TABLE B
WIRING CHANGES MADE ON ISSUE 22

TABLE A
WIRING CHANGES MADE ON ISSUE 12

FIG. 3
(SD FIG. 3)

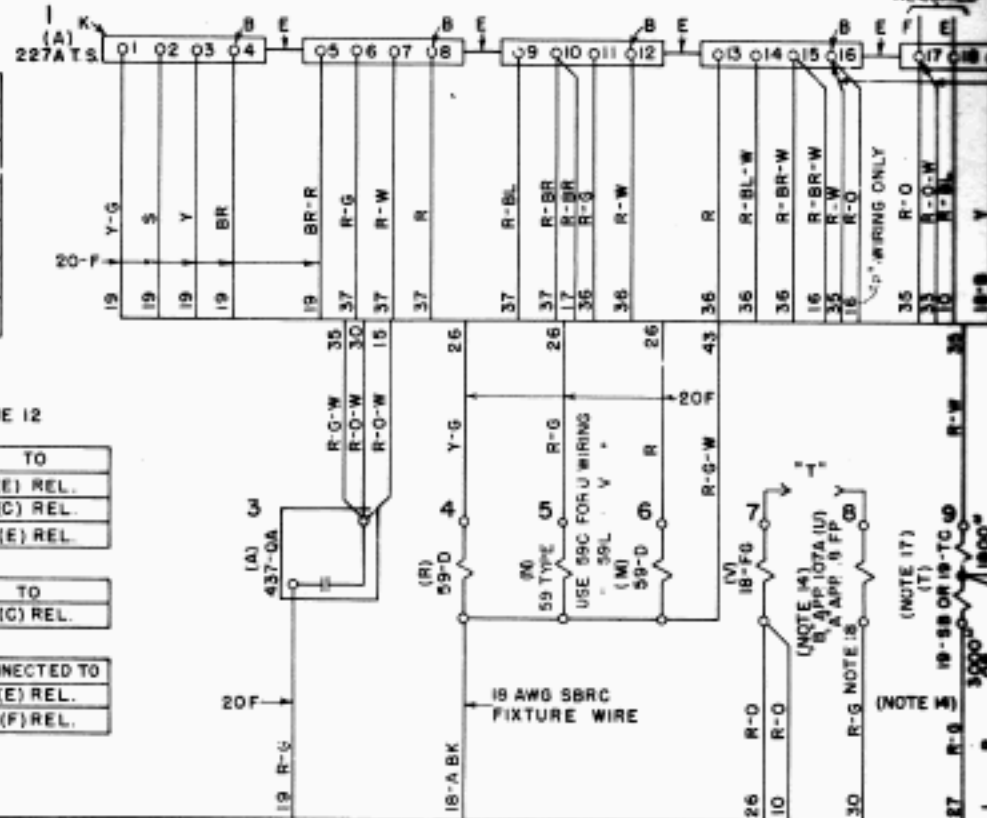
WIRING REMOVED AND ADDED

| COLOR | FROM | TO | REMOVE | ADD |
| R-O-W | A ² COND | B ² F ² REL | X | |
| R-O-W | B ² F ² REL | T ² C ² REL | X | |
| R-G | B ² F ² REL | PCMG 17 A ² T.S. | X | |
| R-G-W | TOP A ² COND | T ² C ² REL | | X |
| R-O | T ² C ² REL | PCMG 17 A ² T.S. | | X |
| R-G-W | B ² F ² REL | BOTTOM C ² RES | | X |
